RESPONSE TO FCC CORRESPONDENCE REFERENCE NO. 32032

Re: FCC ID LO6-DVRSUHF

Applicant: Futurecom Systems Group Inc Correspondence Reference
Number: 32032

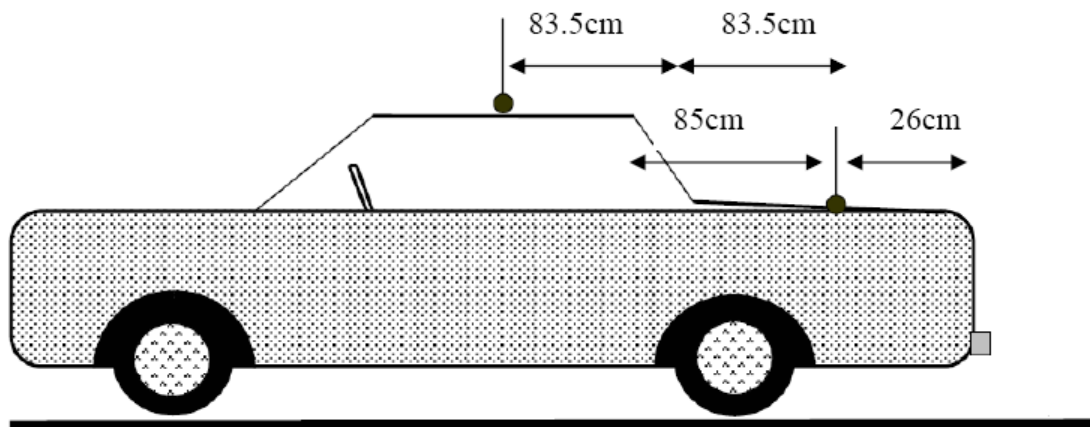
10) Figure in Appendix A shows 83.5 cm from roof edge to trunk antenna; SAR part says trunk antenna is 26 cm from end of trunk - please explain how antenna to trunk edge distance is same as in MPE test, or explain Why if different.

The illustration in Appendix A is a top view of by-stander positions (1-5) which includes lateral distances from the car body along with roof and trunk mount antenna locations. The front and rear windshields are not included in the illustration and therefore the roof edge to the trunk is not practical. The sole purpose of the 83.5cm was to demonstrate that by-stander 2 is positioned at an equal distance between the roof and trunk mounted antennas (refer to note 2 in Appendix A). The rear window is partially included in the 83.5cm distance. The 26cm distance is from the trunk mount antenna to the trunk edge towards the rear of the automobile. Refer to figure below.
